Heritage Victoria
Department of Transport and Planning
2 Lonsdale Street,
Melbourne, Victoria 3000

**Re: Hepburn Mineral Spring Reserve (H2098)
Hepburn Pavilion Flooring Proposal
Permit Application P40269, RFI Responses**

Proposed jack base detail (*Quatrefoil*)

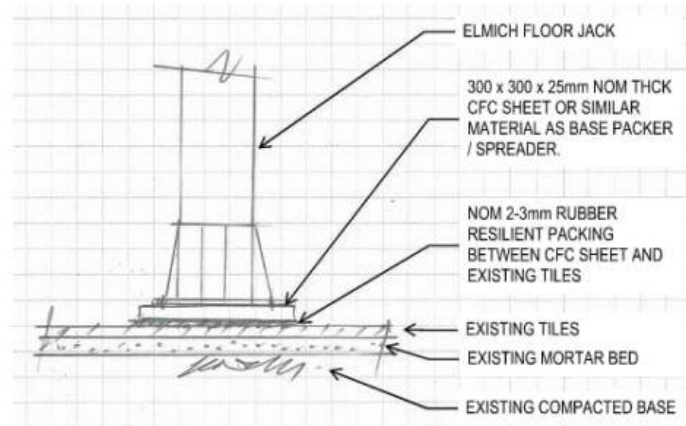
The Heritage Impact Statement outlines two options for resting the proposed pedestals on the original flooring: option A which involves resting the pedestal bases directly on the encaustic tile flooring, or option B which involves layers of protection on top of the flooring that will also level out the space. In reviewing the options it would appear that option B is preferable given the additional protection it places on the original flooring when compared to option A, and some form of protection would be expected prior to installation of the proposed raised flooring. Please provide further information on which option is recommended to have the best long-term outcome for the original tiling, and the rationale for the recommendation.

Following further consultation with Quatrefoil Engineering, a new hybrid solution has been designed to achieve the best long-term outcome for the original tiling. The proposed design incorporates an additional bearing plate with resilient rubber packing beneath the proposed Versijack pedestals. The proposed system is as follows:

- The pedestal jacks will be set on 25mm CFC (compressed fibre cement) sheet bearing plates, sized to match the pedestal base;
- Each bearing plate will rest on a layer of resilient neoprene sheeting to provide further protection to the original tiles.

This system has been specifically engineered to further mitigate point loading on the original tiles, a key consideration in maintaining the integrity of the heritage flooring. Simultaneously, it allows the proven moisture desorption process to continue unhindered, which was the primary concern when determining the appropriate flooring solution. The inclusion of resilient rubber packing beneath the CFC bearing plate acts as an additional

protective layer, 'cushioning' the tiles from the rigid spreader and ensuring the conservation of the original fabric. The proposed introduction of subfloor ventilation is intended to prevent the accumulation of moisture within the environment. Considering the unique challenges within the space, we consider this option to be most suitable with the best long-term outcome for the original tiles.

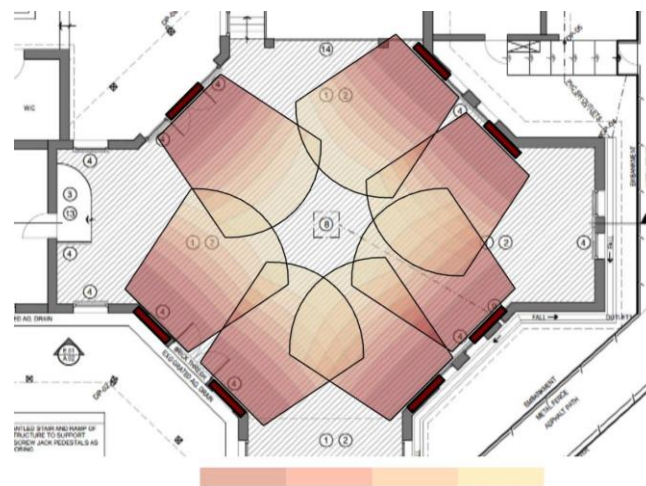
Please provide structural engineering advice regarding the suitability or limitations of the proposed pedestal system for different loading scenarios, such as anticipated normal usage, or events with high attendance numbers.

Further advice from Quatrefoil Engineering has confirmed that the proposed flooring solution is suitable for the space. In response to this advice, it is proposed that the flooring system is bolstered by incorporating two 22mm layers of James Hardie Secure Interior subflooring. This configuration exceeds the maximum loading requirements for all relevant activity and occupancy types as outlined in AS1170.1.
